Site Built Form Review

29-31 SECOND AVE

Cox Richardson has been asked by Blacktown City Council to review the development application with regards to the built form of a residential development at 29-31 Second Avenue, located to the north of the Blacktown CBD.

Figure 4 - SEPP 65 Compliant Building Separation Study

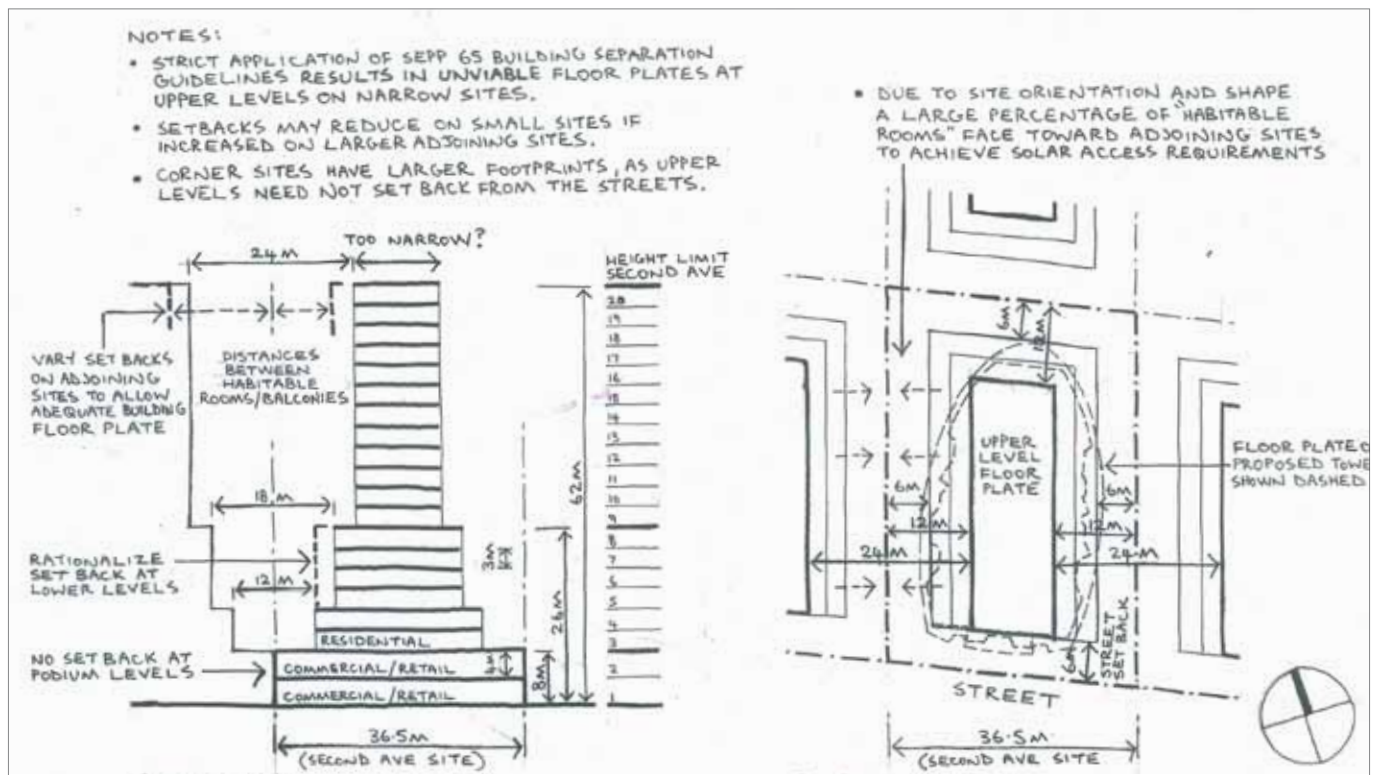
Figure 6 illustrates the SEPP 65 compliant building envelopes for 29-31 Second Ave and the two adjacent sites.

As shown in black, adhering to the SEPP 65 building separation guidelines on the 29-31 Second Avenue site results in a narrow and inefficient building envelope.

However, as shown in red, if setbacks are applied collectively across the three sites, rather than on a site-by-site basis, the resulting building envelope on 29-31 Second Avenue and the adjacent sites, achieves a much more efficient residential tower width of 22m (with 4m allowed for balconies) rather than a stepped building.

In order to achieve an effective mix of uses and to provide an active non-residential street edge. It is proposed that SEPP 65 controls for setbacks be applied to the residential tower on a 'height above podium' basis, rather than as 'height above ground level'. This would achieve the intended mixture of uses within the precinct without detracting from either residential yields or public amenity.

Figure 5 - Alternative Building Separation Study

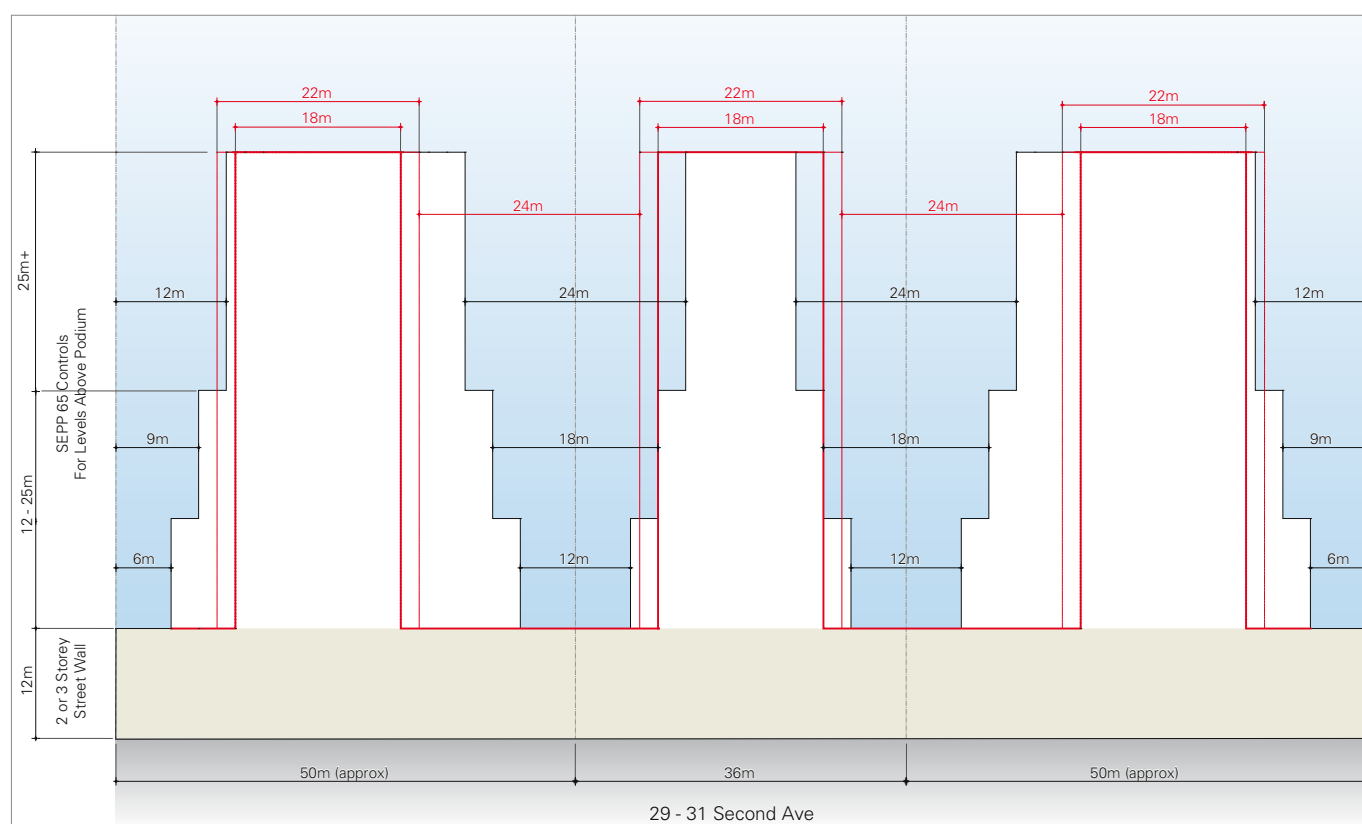
The current proposed residential tower is some 27 metres in width, although this varies as the building is curved. Note also that the adjoining towers are located asymmetrically within their sites to allow all three sites to accommodate 22 metre wide buildings.

An acceptable cumulate built form outcome could therefore be achieved by reducing the proposed tower in width and assuming that buildings of 22 metres maximum width would be located on adjoining sites.

Figure 6 - 29-31 Second Ave - Overshadowing Diagram - June 21

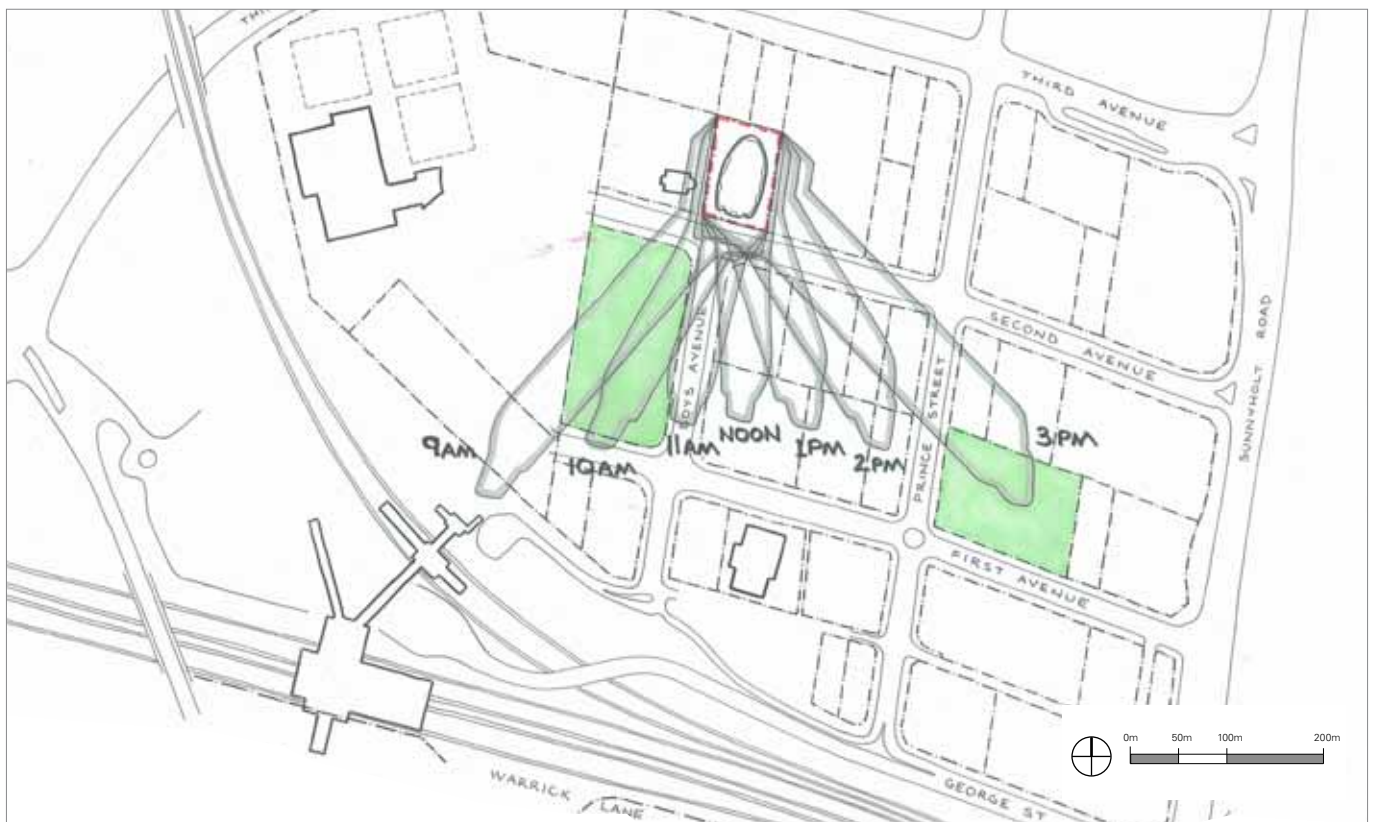
Individually, the proposal for 29-31 Second Avenue currently satisfies the required solar access for the parks (as shown by Figure 6).

Figure 7 - 29-31 Second Ave - Proposed Floorplan and Elevations

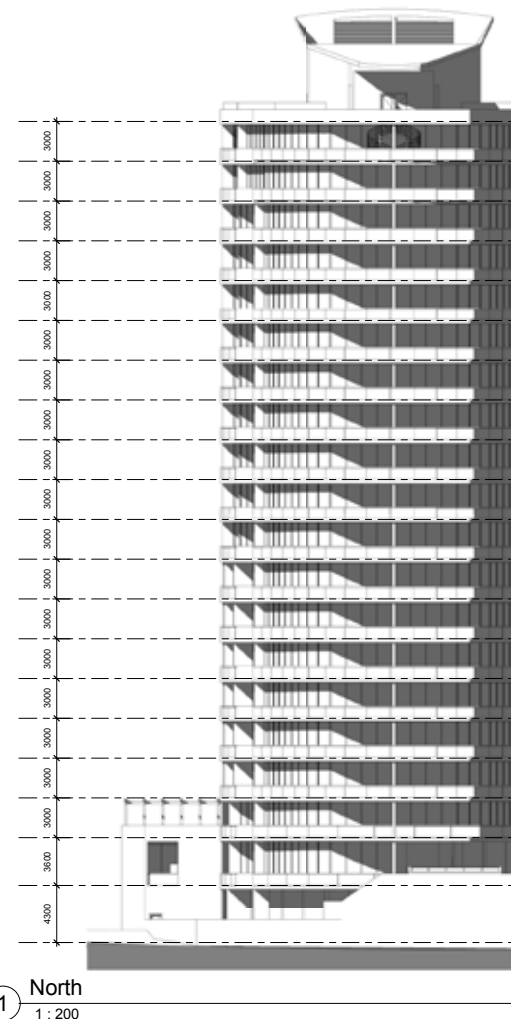
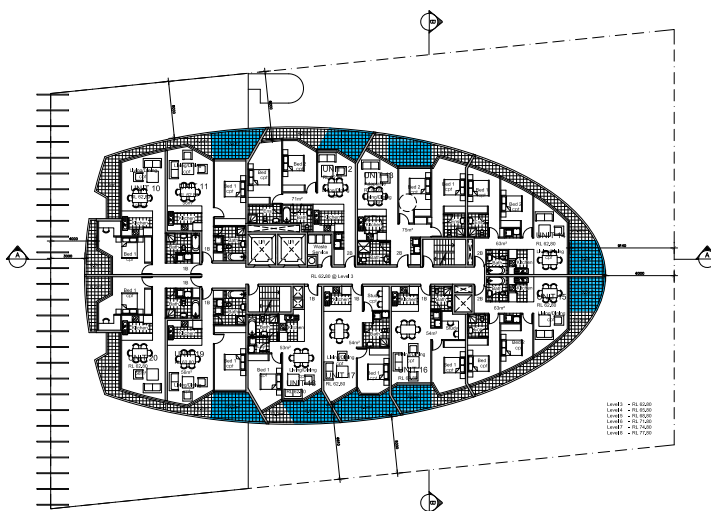
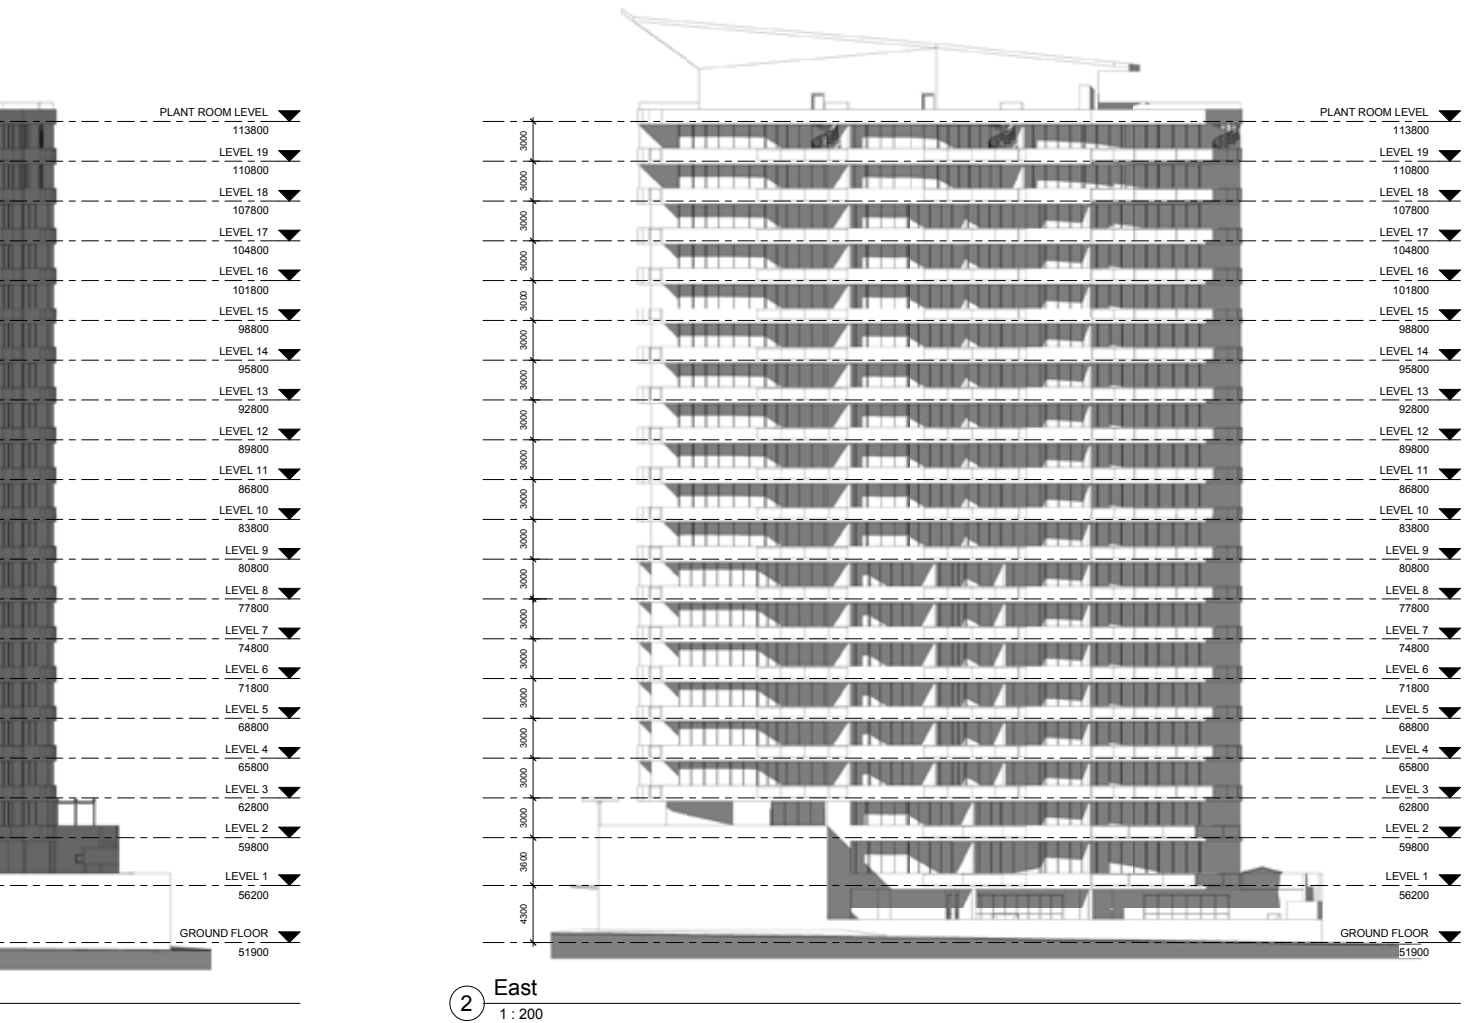
- SEPP 65 GUIDELINE: 70% of apartments are required to receive about 3 hours of winter sunlight between 9am and 3pm.
- COMPLIANCE: Approx 105 apartments = 63% (similar the applicant's SEE noting that 105 apartments comply)

- SEPP 65 GUIDELINE: a maximum 10% of apartments to have a single aspect to the south
- COMPLIANCE: 9 apartments = 5.4%

- SEPP 65 GUIDELINE: 60% of apartments to be naturally cross-ventilated
- COMPLIANCE: 71 apartments = 42.3% (the applicants SEE argues that the design of balconies, blade walls and glazing create "areas of varying pressure leading to a natural flow of

- SEPP 65 GUIDELINE: 25% to 30% of site.
- COMPLIANCE: Appears not to comply. The matter is argued at length in a "Letter of additional Information" provided in response to council's concerns. Concerns could be raised about the nature of the separated "communal roof decks" which appear to have access via plant areas.

- SEPP 65 GUIDELINE: Entry to a maximum of 8 apartments per core/corridor. Natural light to lobbies and corridors
- COMPLIANCE: 15 of the 19 levels of apartments have either 9 or 11 apartments per core/corridor. Compounding this is the lack of natural light to any of the lift lobbies or corridors on apartment levels above the second floor.
